Baby 10 Sequencer

Rev 2.1 14 JUN 10 m. herrmann

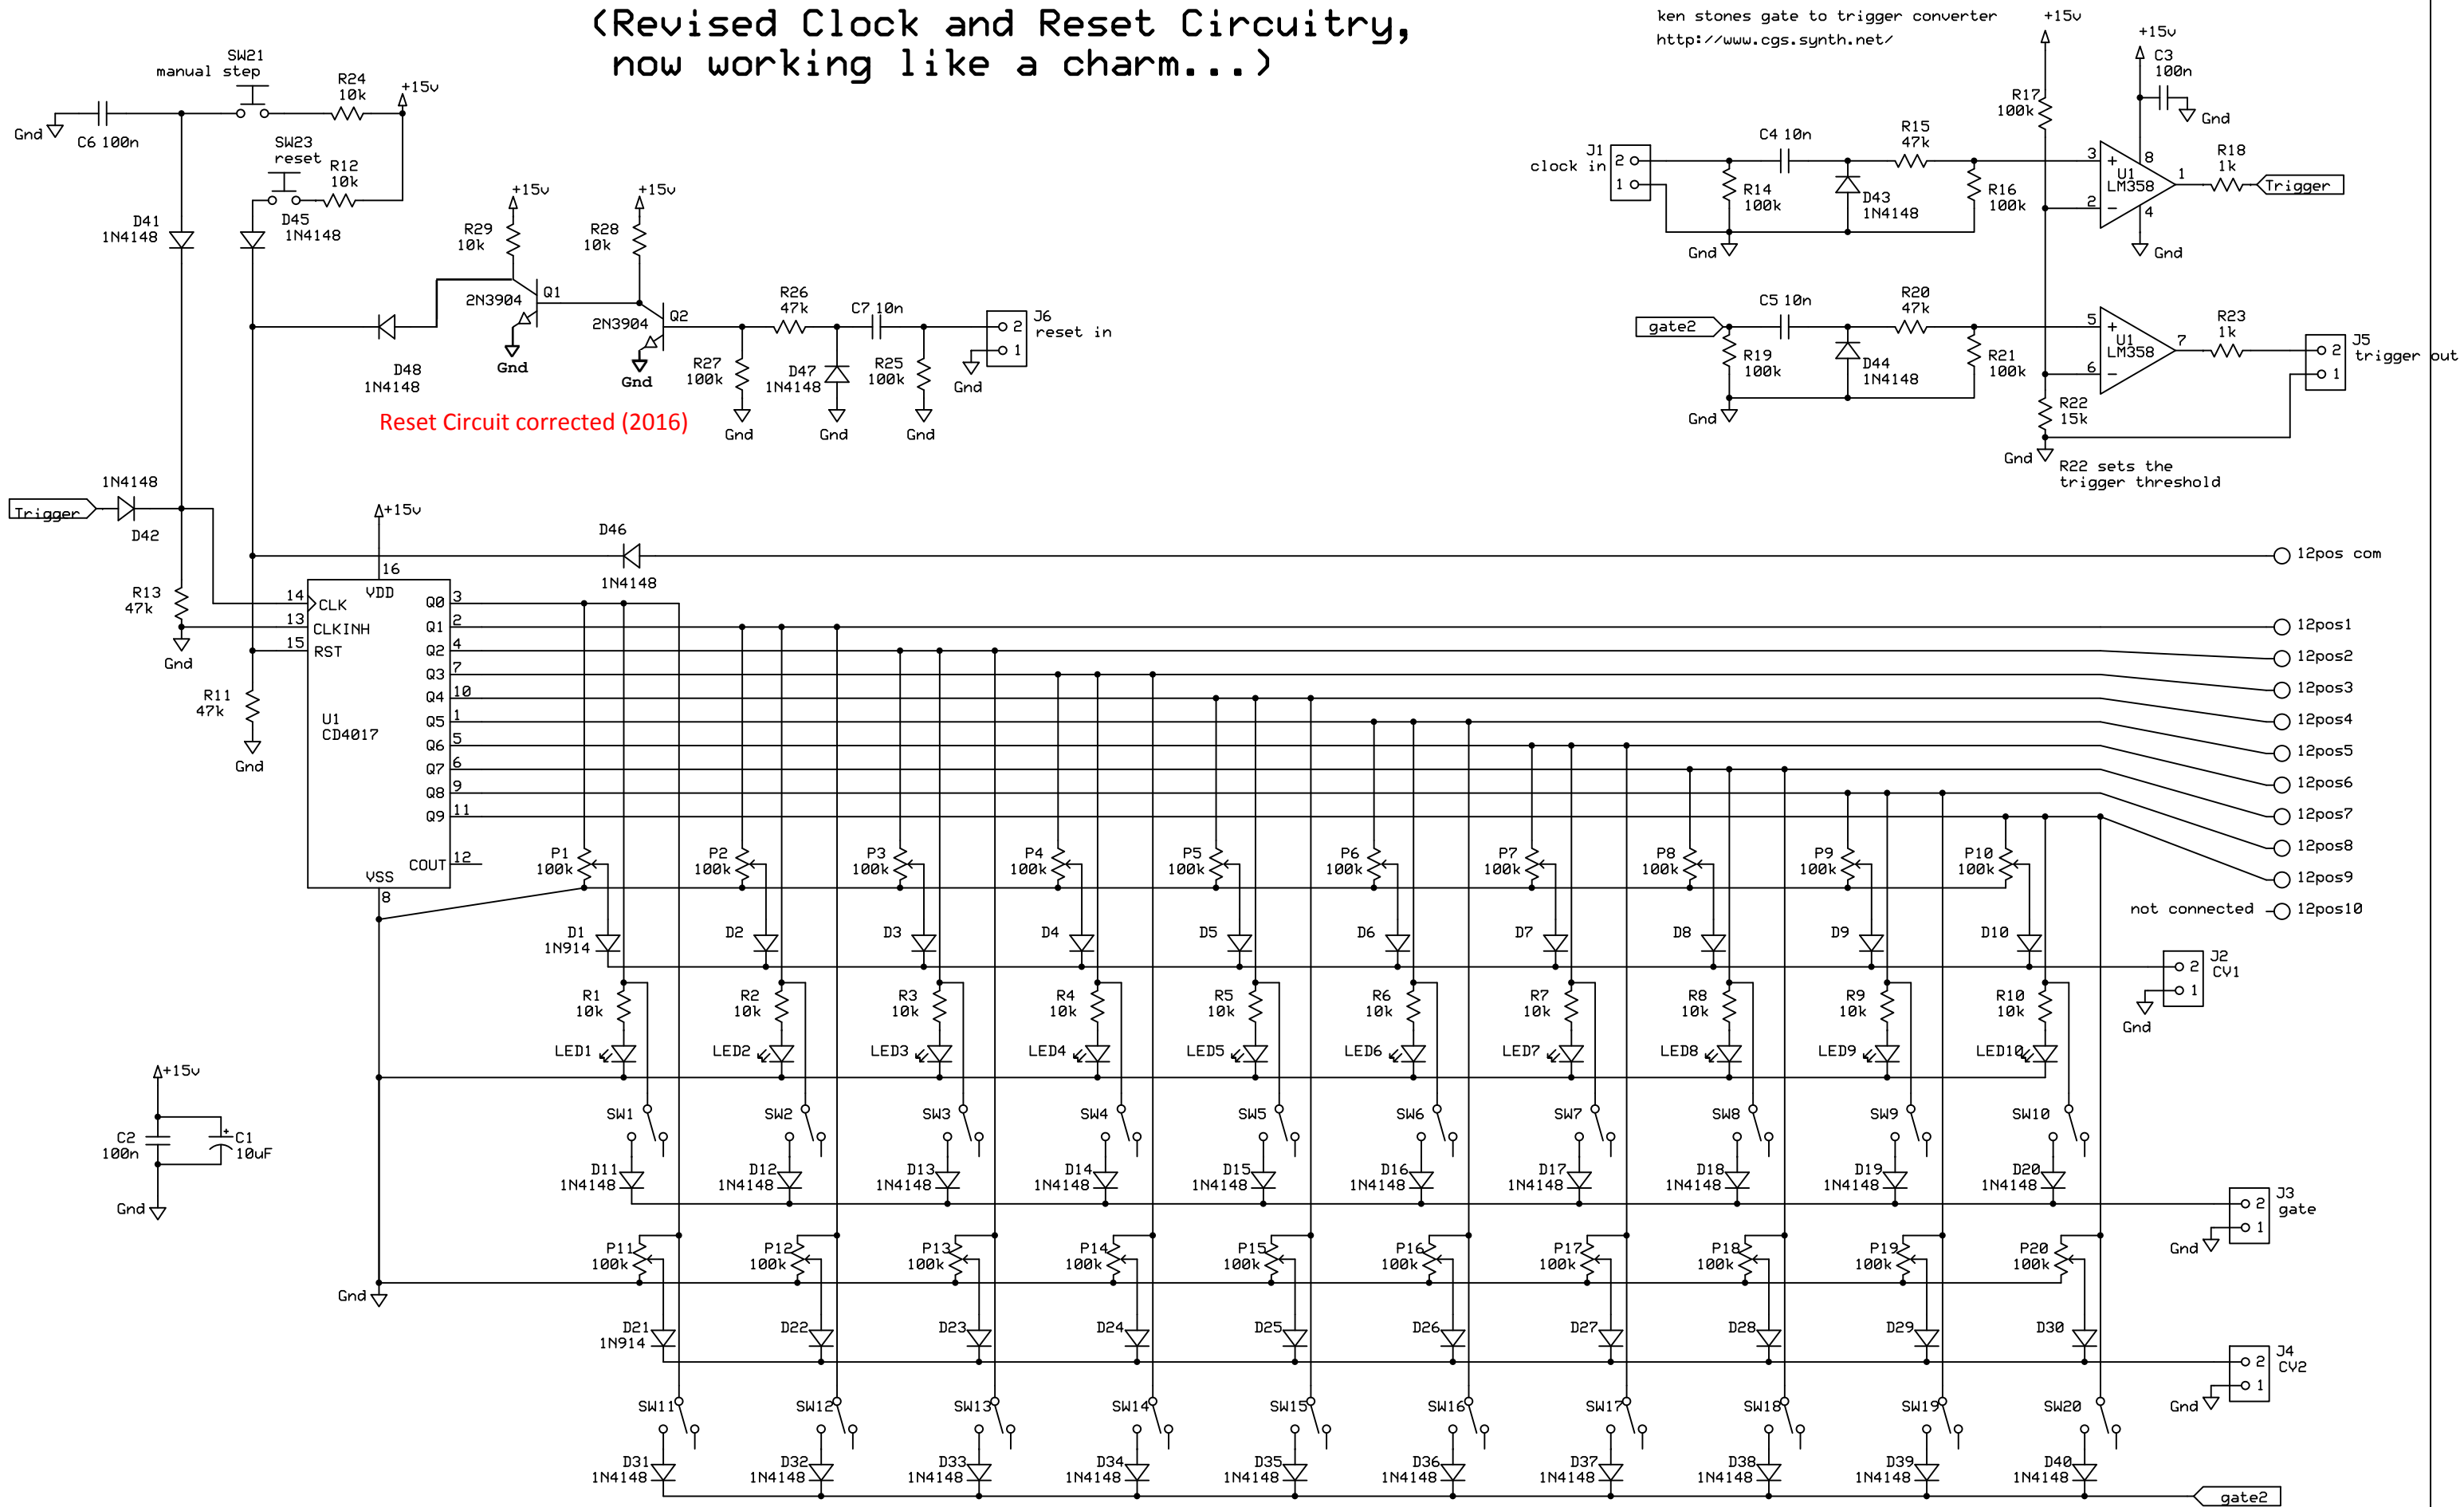
(Revised Clock and Reset Circuitry,
now working like a charm...)

Reset Circuit corrected (2016)

R22 sets the trigger threshold
